# Access Compliance Report

## Public Rights-of-Way

### (Curb Ramps)

Intersection ID: 10017483	Main Street: E_W_T_HARRIS_BV	Cross Street: N/A	Location: W
ADA ID: B3840551C209	Ramp Type: Perp	Initial Pass/Fail: Pass	Overall Compliance: No
Severity Score: 15.25			
Codes/Mitigation Info/Possible Solution		Field Measurements/Component Compliance

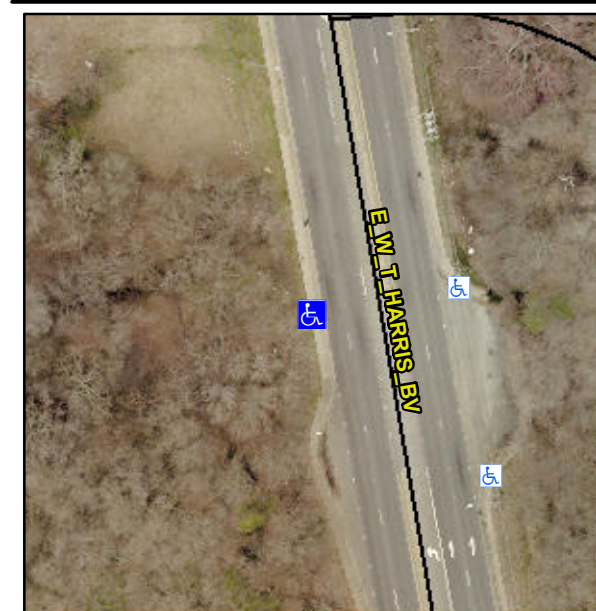
**Not Found, R304.5.3, R304.2.1,  
R304.2.2-Perp, R304.3.2-Para,  
R304.5.4**

Compliance	Description	Data	Compliance	Description	Data
N/A	Ramp Length (in)	61.0	Yes	Ramp Slope (%)	6.7
Yes	Ramp Width (in)	48.0	No	Ramp XSlope (%)	4.3
N/A	Flare Type LT	Sloped	N/A	Flare Type RT	N/A
N/A	Flare Slope LT (%)	3.6	Yes	Flare Slope RT (%)	9.5
N/A	Flare Traversable LT?	Yes	N/A	Flare Traversable RT?	Yes
No	Landing Length (in)	N/A	Yes	DWS Provided?	Yes
No	Landing Width (in)	N/A	Yes	DWS Contrast?	Yes
No	Landing Slope (%)	N/A	Yes	DWS Length (in)	24.0
No	Landing X Slope (%)	N/A	Yes	DWS Full Width?	Yes
N/A	Landing Curb? (Y/N)	No	Yes	DWS Offset (in)	0.0
N/A	Shared Landing?	No			
Yes	Gutter Ponding?	No	No	Gutter Slope (%)	6.2
Yes	Gutter Lip Ht (in)	0.0	Yes	Gutter X Slope (%)	0.7
N/A	Painted X Walk1?	No	N/A	Painted X Walk2?	N/A
	X Walk 1 Direction	To E		X Walk 2 Direction	N/A
N/A	X Walk 1 Width (in)	N/A	N/A	X Walk 2 Width (in)	N/A
	X Walk 1 Slope (%)	2.9		X Walk 2 Slope (%)	N/A
	X Walk 1 X Slope (%)	0.5		X Walk 2 X Slope (%)	N/A

**Remove & Replace Entire Ramp.  
Remove & Replace Gutter.**
